**Eastonville Road – Londonderry Drive to Rex Road
Segment 1 Improvements
Stationing 14+19.69 – 47+66.51**

Final Drainage Report

August 2024

EDARP File No.: CDR2321

SHEET DRN 1

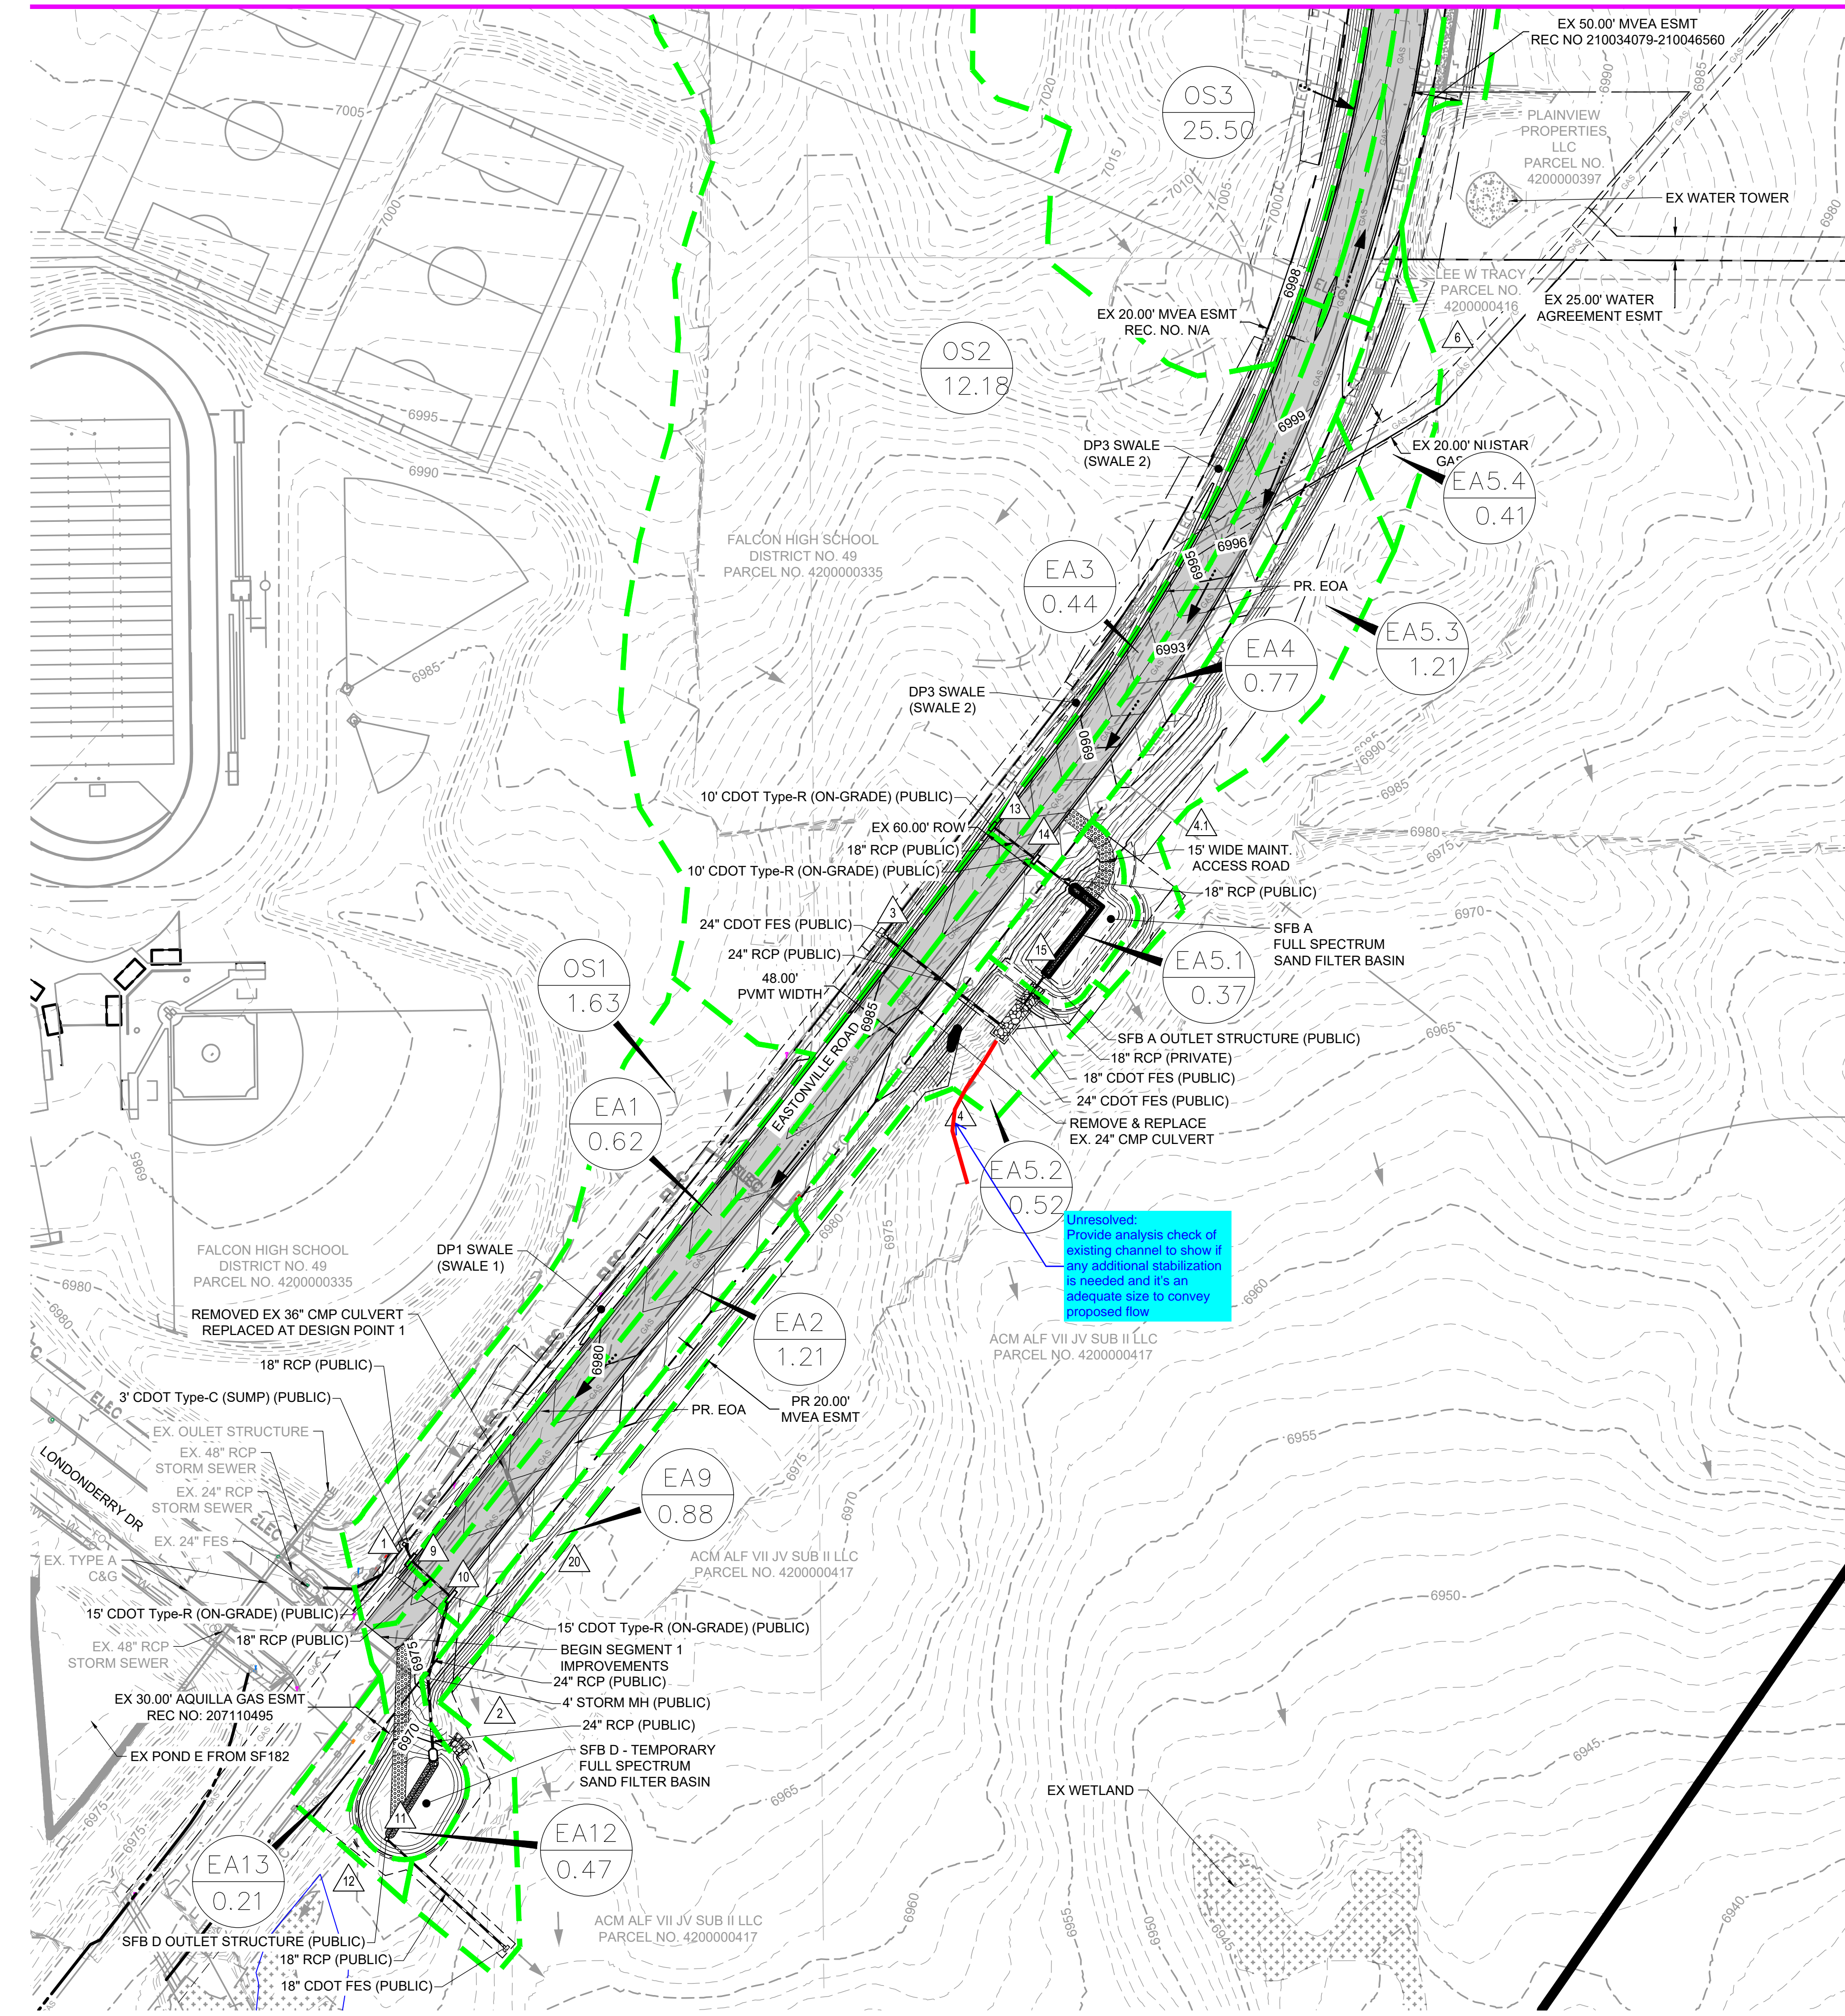
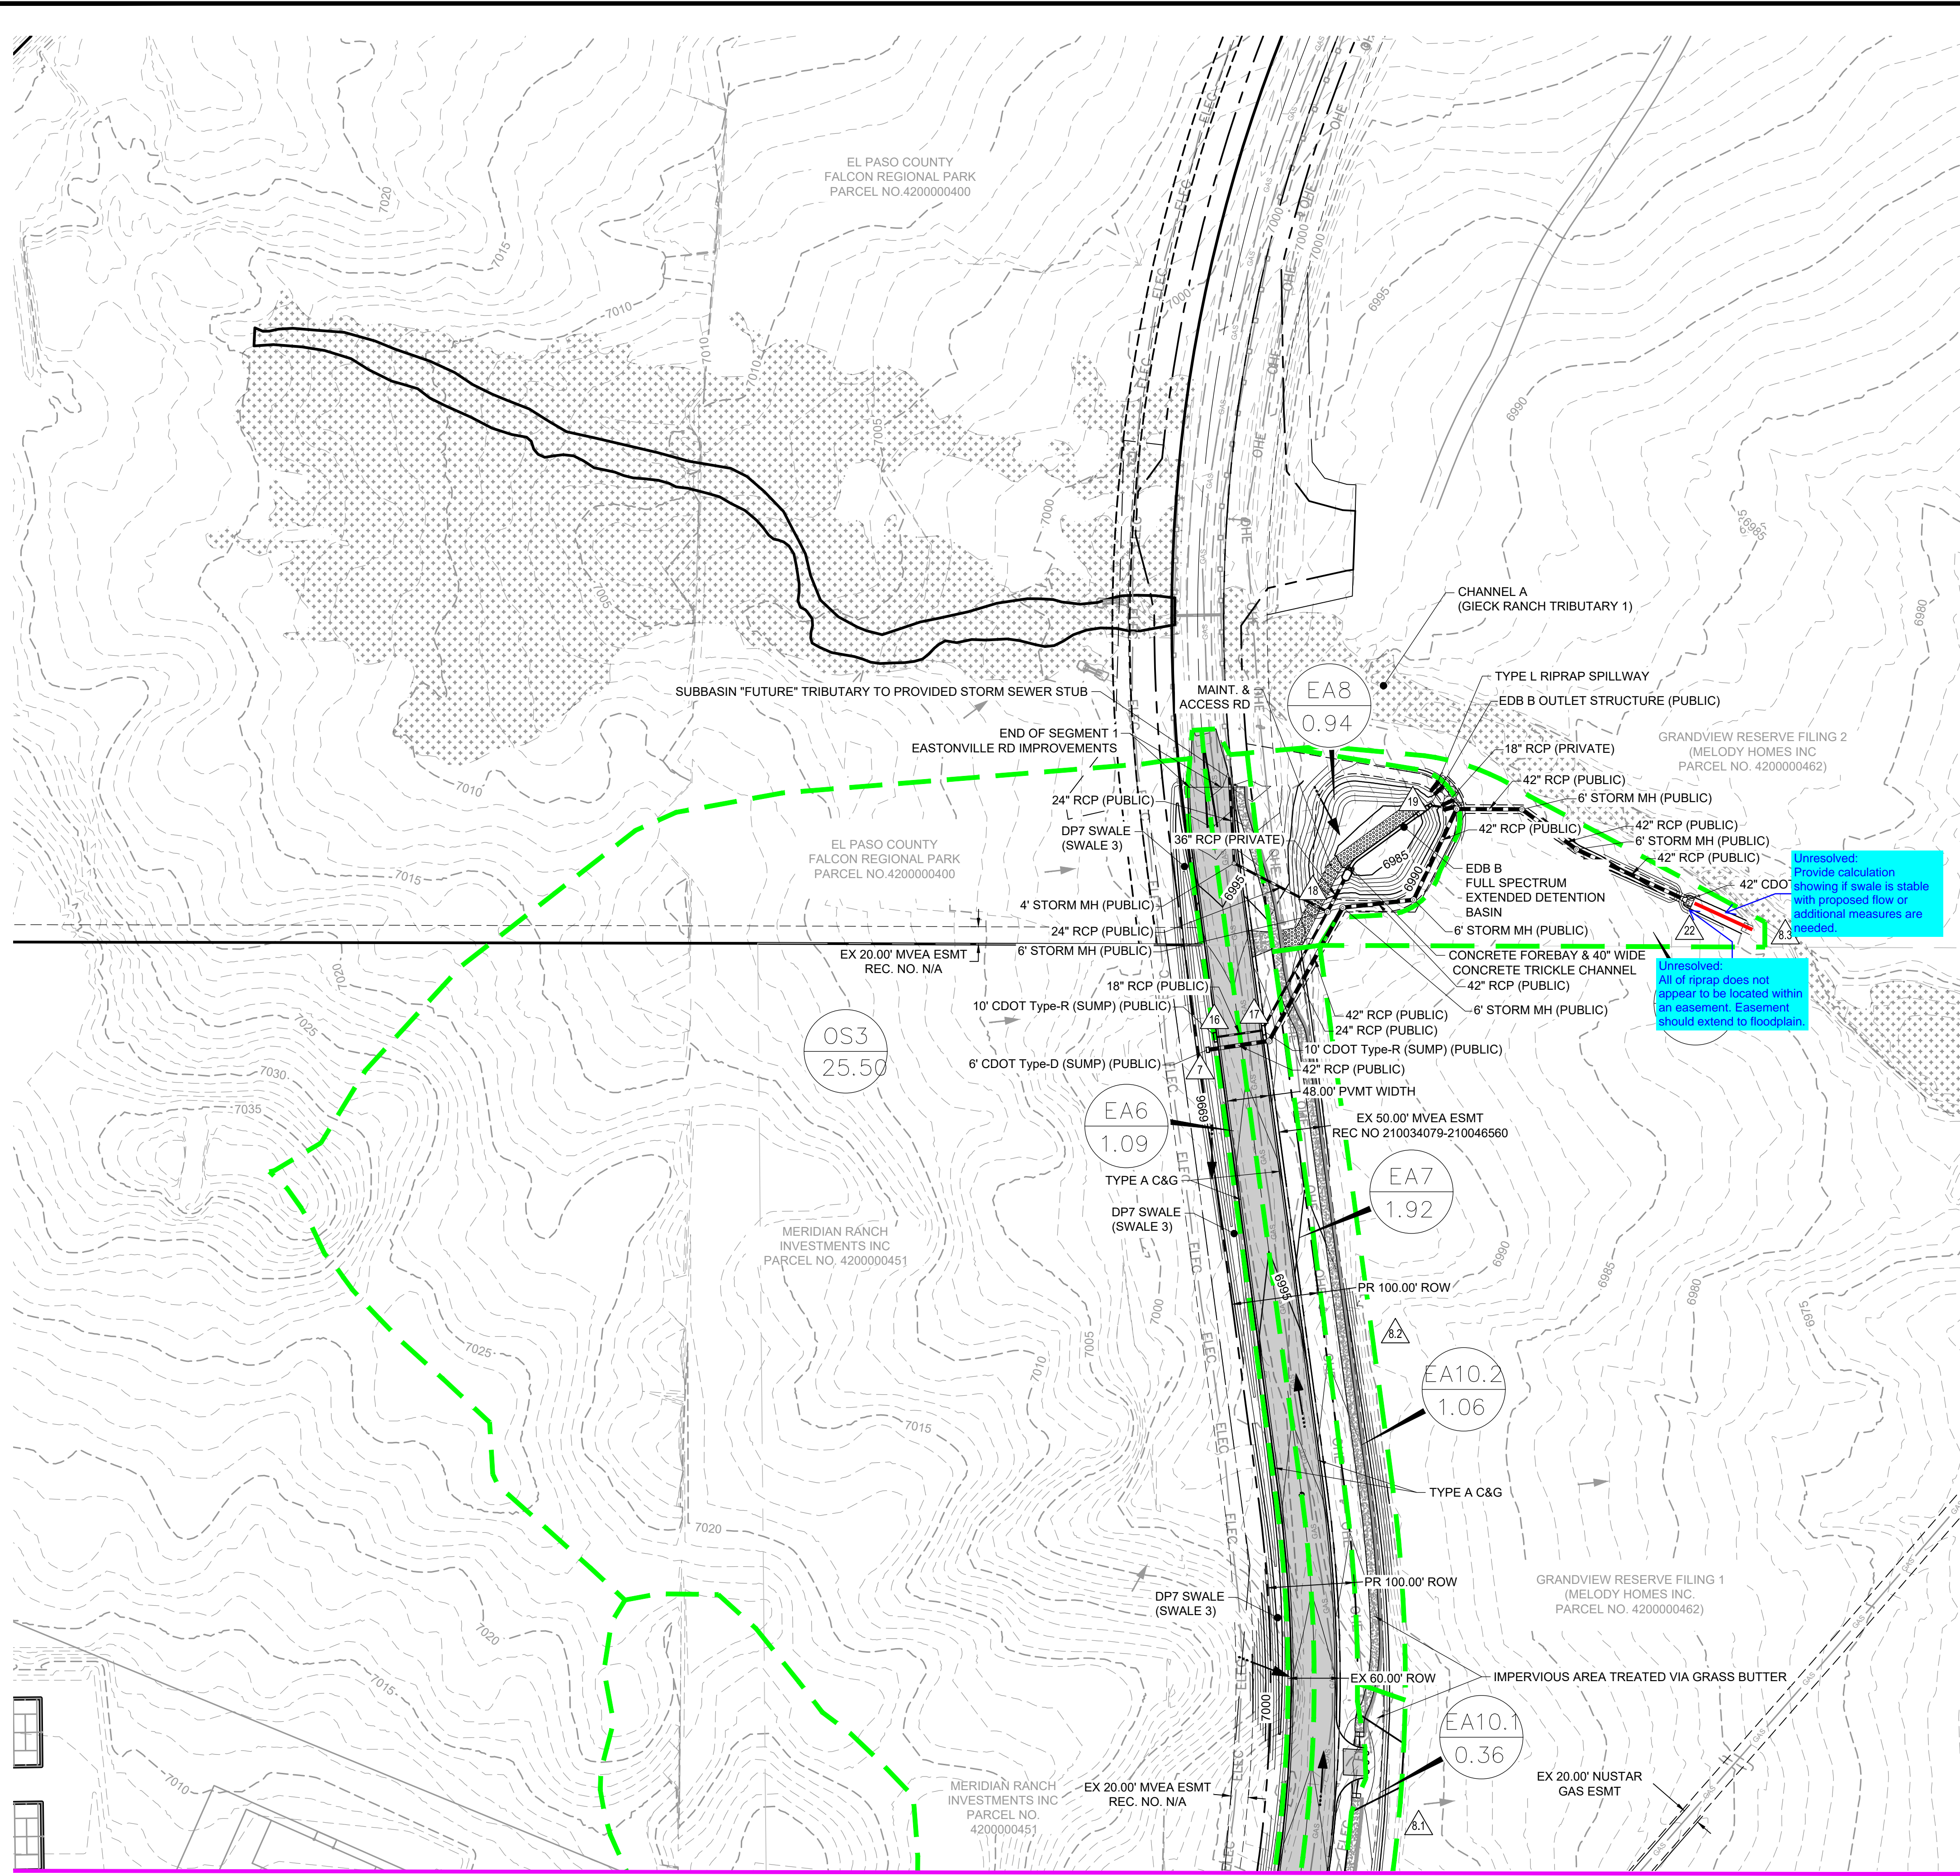
Review 2 update: these 3 "offsite undeveloped areas" are still shown on the drainage map as having proposed disturbances. Meaning that they are neither "offsite" or "undeveloped." Please revise map and descriptions to add onsite basins for the areas of disturbance and discuss WQ treatment or applicable WQ exclusions. Just stating that infiltration is occurring is not enough. You'll need to show Runoff Reduction calcs for RPAs and/or SPAs or an applicable exclusion.
